# SERVICE BULLETIN

ENGINE - LP COMPRESSOR - PROVIDE A NO.2 BEARING OIL JET ASSEMBLY WITH A REVISED LENGTH LOCATION PIN - CATEGORY CODE 6 - MOD.ENG-72-0047

V2500-ENG-72-0047

View showing No.2 bearing oil jet assembly  
Fig.1

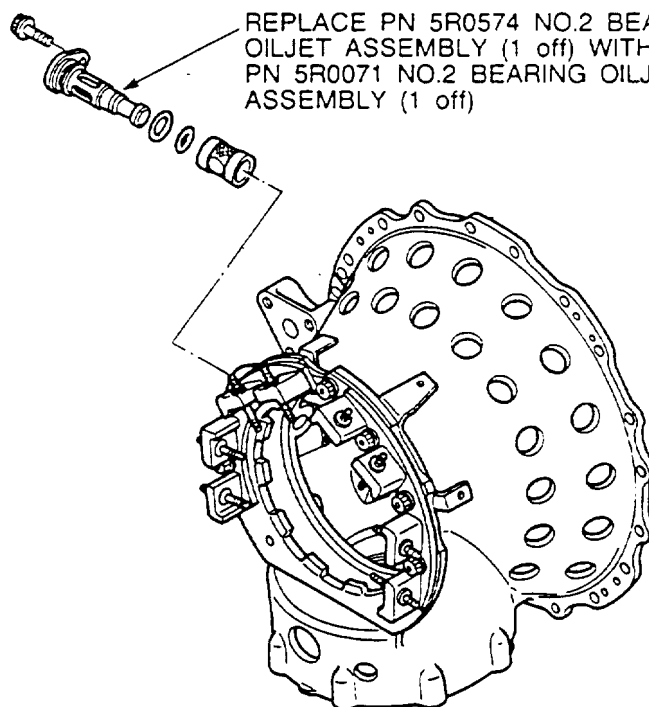
As length of existing locating pin is shorter than oil passage inner diameter, the pin could fall into the oil passage. A longer locating pin has been provided. One end of the new pin reaches to the opposite inner wall or the oil jet body through the oil passage.

REPLACE PN 5R0574 NO.2 BEARING OILJET ASSEMBLY (1 off) WITH PN 5R0071 NO.2 BEARING OILJET ASSEMBLY (1 off)

(1) Install 5R0071 No.2 bearing oil jet assembly by Figure 1 and approved procedure in Reference (2), Chapter/Section 72-32-10, Assembly.
